WASHINGTON CITY
PLANNING COMMISSION MEETING
STAFF REVIEW

AGENDA ITEM:	5a
HEARING DATE:	February 21, 2024
ACTION REQUESTED:	Preliminary Plat approval for the Iron Top at Long Valley Subdivision, located at approximately Long Valley Road and Forbidding Way
APPLICANT:	DR Horton
OWNER:	DR Horton
ENGINEER:	American Land Consulting
REVIEWED BY:	Eldon Gibb, City Planner
RECOMMENDATION:	Recommend approval with conditions to the City Council

Washington City – FIRST FIRE REVIEW

Re: Plan Review: Long Valley Trails Preliminary – SITE- FIRE APPARATUS ACCESS ONLY
Address: Washington, UT

**FIRE & LIFE SAFETY PLAN
PRELIMINARY PLAT**

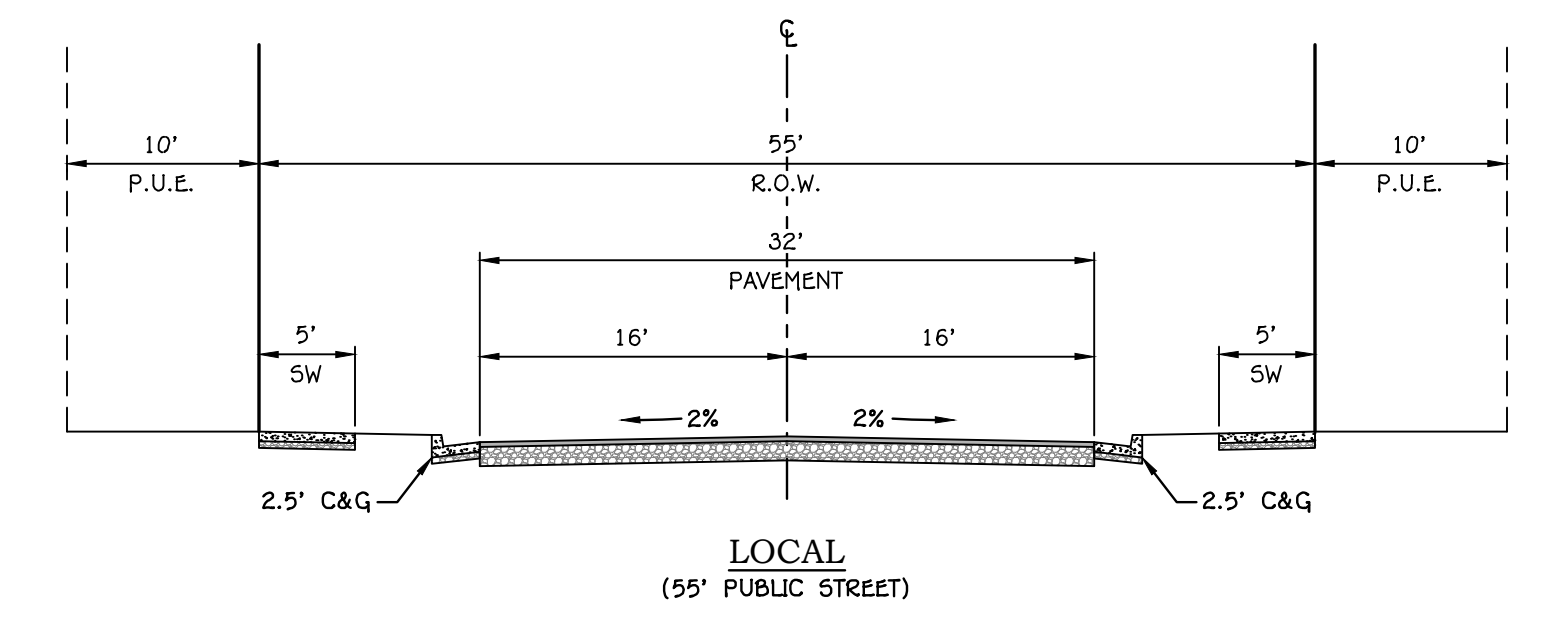
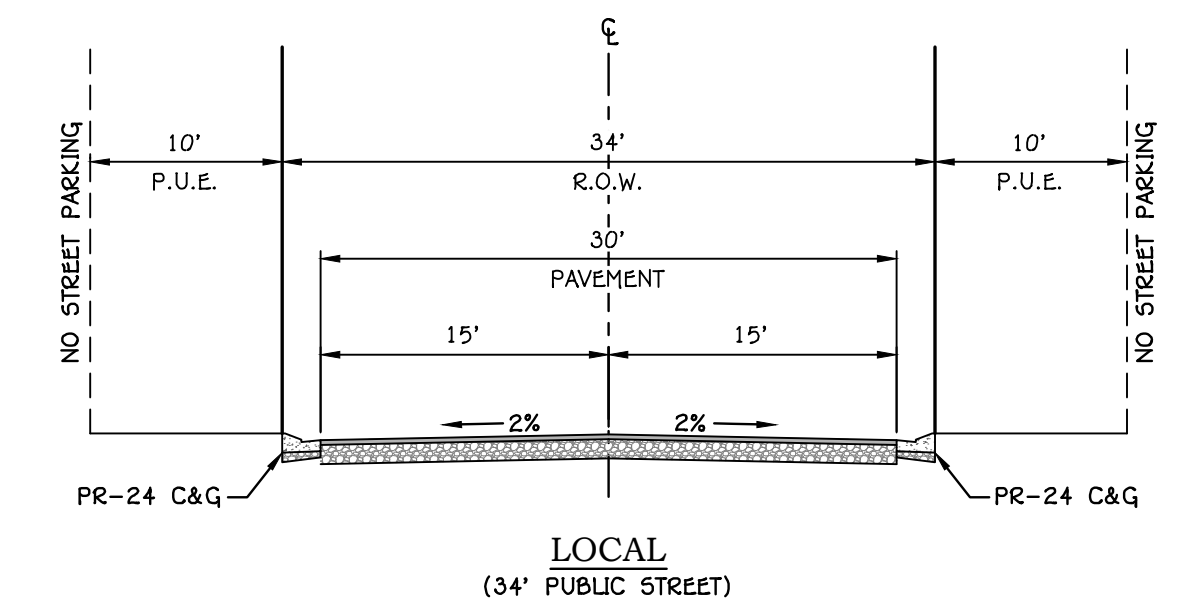
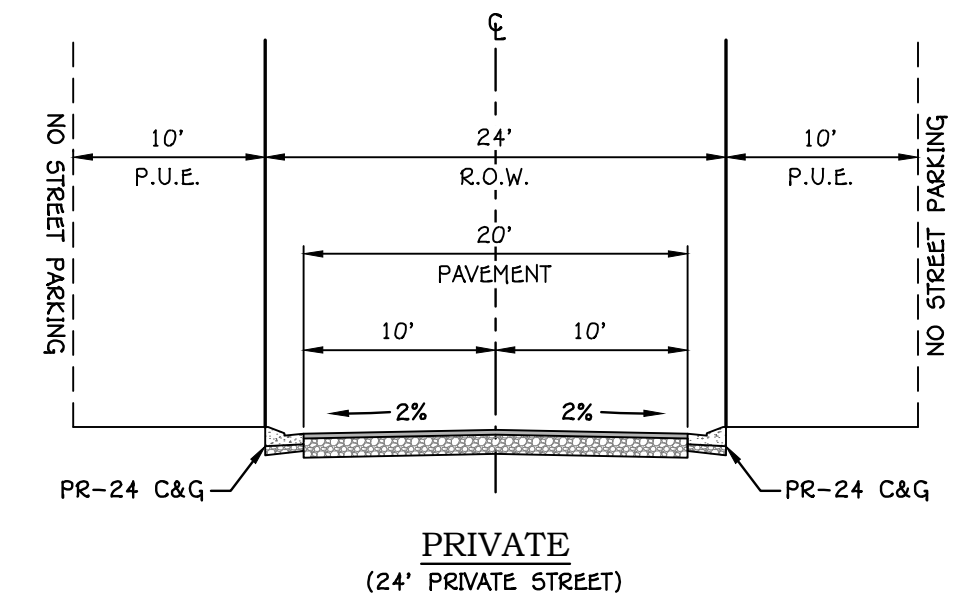
- F1. Sheet 1: **Fire Apparatus Access: Aerial Equipment:** Please have the permit applicant address the following on the plans:

The building(s) are greater than 30 feet tall, so aerial (ladder truck) access is required. The road shall be located so the near edge to the building is a minimum of 15 feet and a maximum of 30 feet from the building and shall be positioned parallel to at least one side of the building.

Overhead utility and power lines shall not be located over the aerial fire apparatus access road or between the aerial access for and the building.

Fixed obstructions on the entire length of the designated access-road side shall not interfere with the operation of an aerial ladder placed at a climbing angle not exceeding 75° from the turntable plane to: a) all rescue and emergency egress windows on that side, or, b) the entire roof where rescue and emergency egress windows are not required or provided, or, c) to the fullest extent of the aerial ladder effective reach. [IFC Appendix D§105.1]

- a) Identify on the plans the designated aerial (ladder truck) fire apparatus access side,
- b) Provide a sectional drawing of an aerial apparatus with the ladder not exceeding 75° accessing a), b) or c) above.

F2. Sheet 1: **Fire Apparatus Access: Road Load-bearing Capacity.** Please have the permit applicant address the following on the plans:

The plans do not appear to address the minimum load-bearing capacity for the fire apparatus access roads.

- a) Fire apparatus access roads shall be designed to support an imposed load of not less 75,000 pounds. [IFC §503.2.3 and IFC Appendix D-§102.1]
- b) Please have the permit applicant provide a road and substrate section on the plans and include a civil engineer's load-bearing calculations and stamp for the assembly.

F3. Sheet 1: **Fire Apparatus Access: Aerial Fire Equipment: Stabilizer Point Loads:** Please have the permit applicant address the following on the plans:

- a) The ground contact point for aerial fire apparatus stabilizers shall be capable of supporting not less than 75 psi measured over the area of the stabilizer pads. [IFC §503.1.1 and IBC §1607.7.2]
- b) Please have the permit applicant include the point load calculations on the plans and verify loading surfaces (trench drain covers, subterranean drainage control vaults, utility vaults, etc.) can support the load(s).

F4. Sheet 1: **Fire Lane Signs:** Please have the permit applicant address the following on the plans:

- a) Fire apparatus access roads shall be marked with permanent NO PARKING-FIRE LANE signs and/or painted curbs in accordance with state and local standards. [IFC §503.3]
- b) Please have the permit applicant provide a sign template and locations on the plans.
